# AEBS-HDV IWG Industry input

AEBS-HDV-10 April 26-28

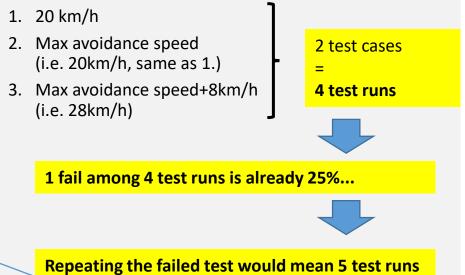
5.4.1.1. The AEBS function shall be automatically reinstated at the initiation of each new ignition engine start/run cycle. This requirement does not apply when a new engine start/run cycle is performed automatically, e.g. the operation of a stop/start system.

Alignment of R131 on supplement 1 to 02 series of R152.
